RE: Amendment C107gpla – Bannockburn South East PSP and DCP

Thank you for the opportunity to make a submission in relation to Amendment C107gpla (the **Amendment**) to the Golden Plains Planning Scheme, and specifically the draft Bannockburn South East Precinct Structure Plan (**PSP**) and Development Contributions Plan (**DCP**) and accompanying planning scheme provisions.

Insight Planning Consultants act on behalf of Josco Pty Ltd (**Josco**), the landowner of land at Levy Road, Bannockburn, which is within the Bannockburn South East PSP area. We are pleased to provide the following submission in response to the Amendment.

FIGURE 3: AREAS OF CULTURAL HERITAGE SENSITIVITY (VicPLAN 2025)

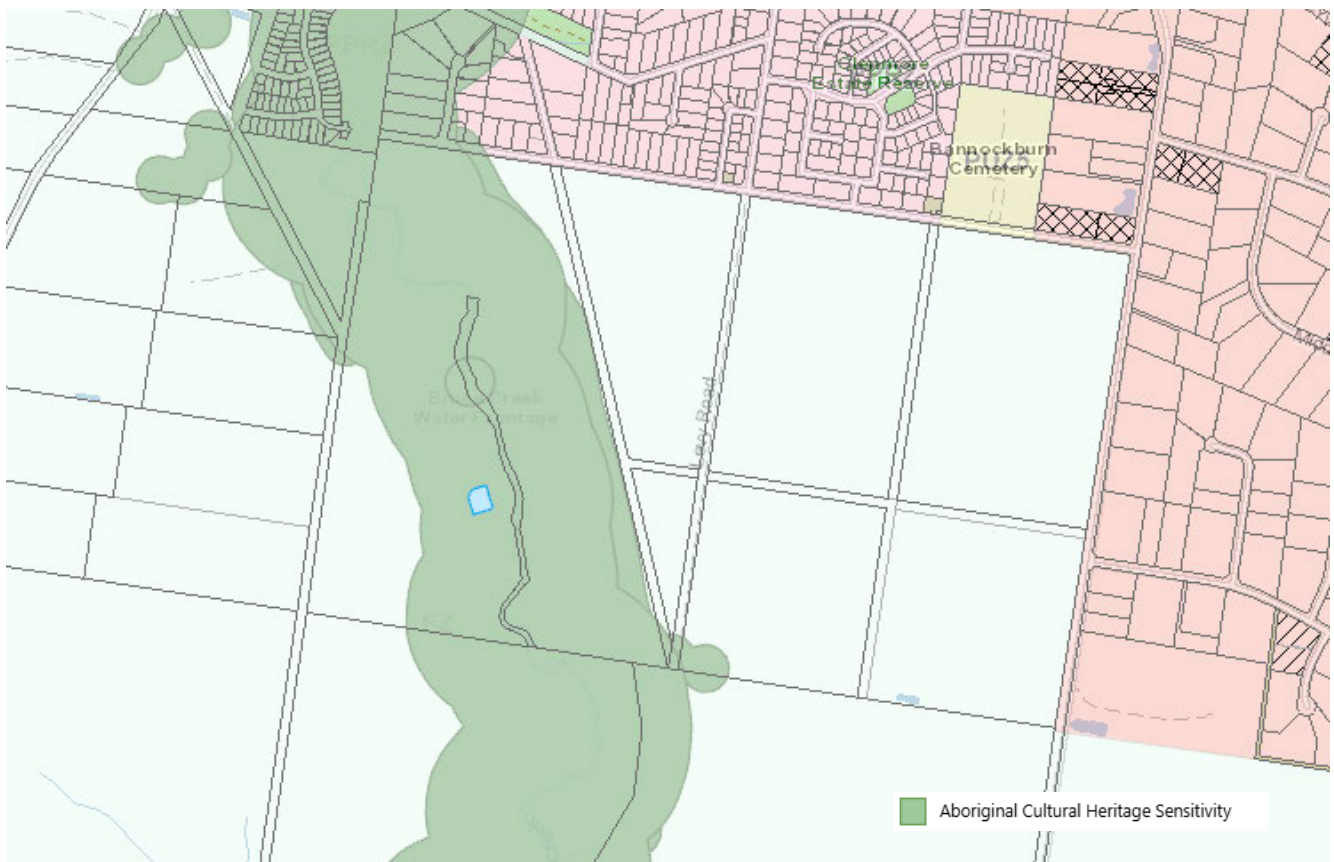
However, the VPA's position, as outlined in Section 4.4.1 *Culturally and/or environmentally sensitive area near Bruce Creek* of their Background Report, that no subdivision or development, drainage or other key infrastructure can occur in these areas unless otherwise agreed and approved, and that the areas of cultural heritage sensitivity have been excluded from NDA, despite having an underlying zone of General Residential

Zone, is questioned. It is well understood that under the relevant aboriginal heritage legislation, a CHMP is required for certain high impact activities within areas of cultural heritage sensitivity.

Parts of the area which is identified as 'artefact scatter' has historically been extensively ploughed, as part of the agricultural use of the Sites. Therefore, unless it can be demonstrated that site-specific investigations have been undertaken on the Sites and determined that there are cultural artefacts within the Bruce Creek corridor on the Sites, this should be deleted from Plan 1 of the PSP. If it is determined as part of a future CHMP process, that there are artefacts located on the Sites, then these will be managed through the CHMP process and as part of future development on the Sites, regardless of any arbitrary identification of such within the PSP.

- Delete identification of 'artefact scatter' from the Sites on Plan 1 of the PSP, unless it can be demonstrated that this is based on site-specific investigation of cultural heritage on the Sites.

FIGURE 6: EXTRACT OF PLAN 3 HOUSING (DRAFT BANNOCKBURN SOUTH EAST PSP)

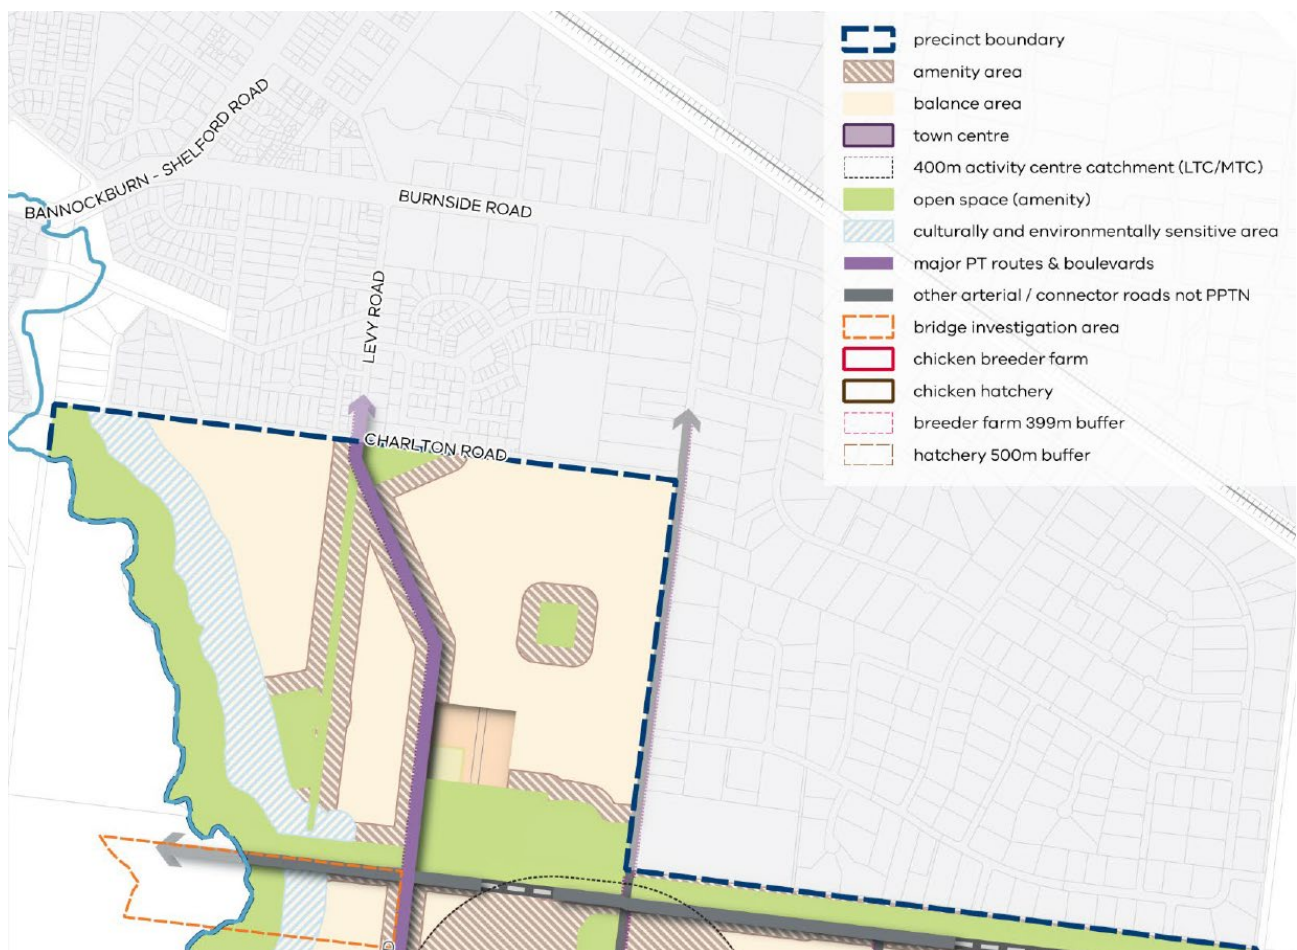
While we do not raise concern with the amenity areas shown adjacent to the proposed local parks or drainage reserves, we consider that the amenity areas adjacent to the open space along the Levy Road reserve, as well as the proposed boulevard connector street are excessive.

While the proposed boulevard connector street is intended to act as a public transport (bus capable) route through the precinct, we do not consider that the entirety of this road will provide a level of amenity to justify

higher densities. Instead, we suggest that higher densities should only occur along the boulevard connector in locations where bus stops are approved. As such, the amenity area along the boulevard connector should be deleted from Plan 3, and instead an additional requirement or guideline within the PSP could be incorporated, if necessary, to encourage increased density surrounding bus stops and other public transport infrastructure.

- Reduce the voluntary target for affordable housing to more closely align to the regional Victorian average.
- Delete Table 5 *Affordable Housing Delivery Guidance*.
- Delete the 'amenity areas' adjacent to the conservation area along the existing Levy Road reserve and the Boulevard Connector Street from Plan 3 of the Draft PSP.

FIGURE 9: EXTRACT OF PLAN 5 PROPOSED GROWTH AREAS (BANNOCKBURN GROWTH PLAN)

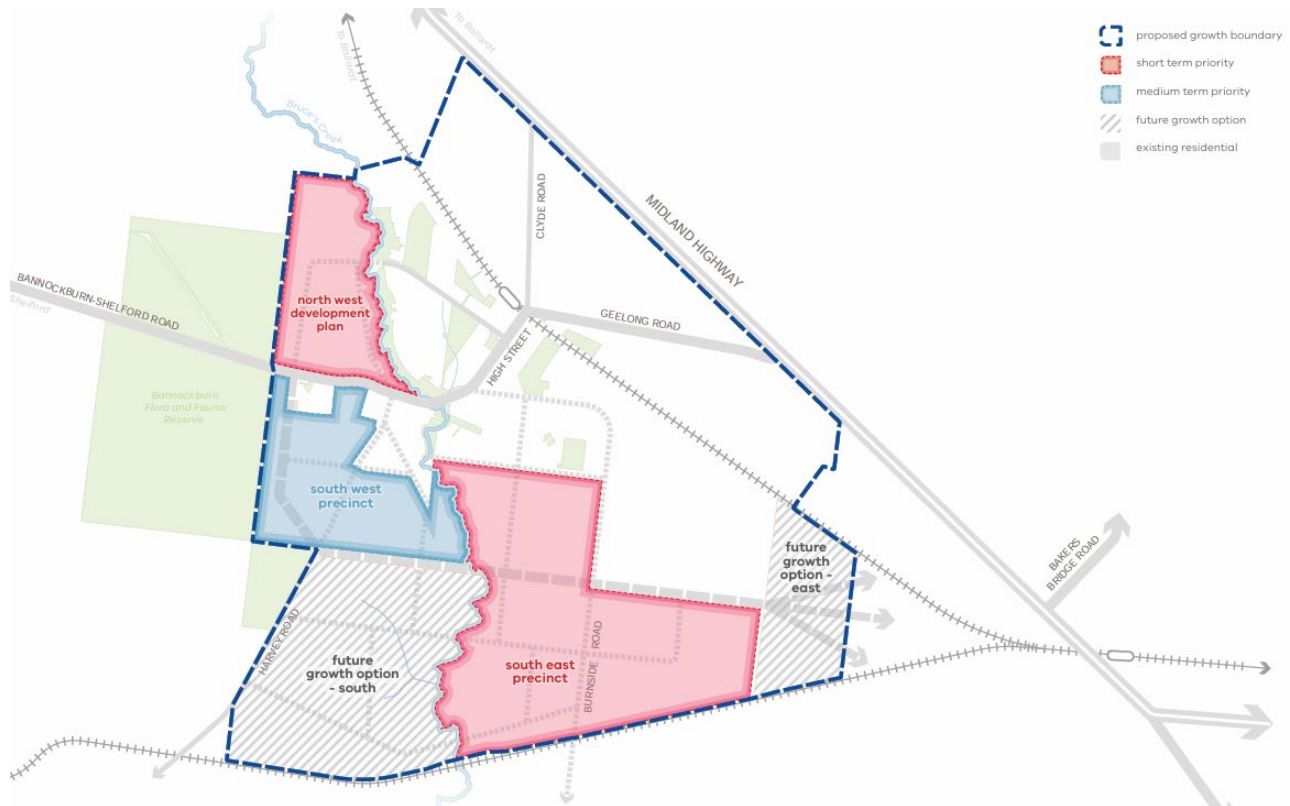
Given that the 'Future Growth Option – South' is a long-term proposition, and could be outside of the time horizon of the Bannockburn South East DCP, it is unreasonable to include this bridge in the draft DCP. There will not be a need for bridge BR-01 until the development of land west of the Bruce Creek is well progressed. As such, our primary position is that BR-01 should be deleted from the DCP.

While the costs for BR-01 have been apportioned 50% in the proposed DCP, and 50% externally, given that most of the demand and anticipated use of this bridge is likely to come from land on the western side of the Bruce Creek, if this project was to be retained in the DCP then this apportionment is also considered unreasonable. The South East Precinct will make up approximately 36% of the total future population of Bannockburn (as based on the population forecasts within the Bannockburn Growth Plan), and it is anticipated that very little of the traffic generated by the precinct will travel west across Bruce Creek at full development as the majority of destinations are located either to the north or east of the precinct. Therefore the apportionment of BR-01 should be significantly reduced.

- Delete BR-01 from the DCP.
- Adjust the scope and cost of RD-01 to delete the section of road west of IN-01.
- Adjust the scope and cost of IN-01 to delete the western leg of the intersection.
- If BR-01 is to be retained in the DCP, the location and design of this bridge must be reviewed to reduce project costs, and the apportionment of BR-01 to the precinct to be significantly reduced.
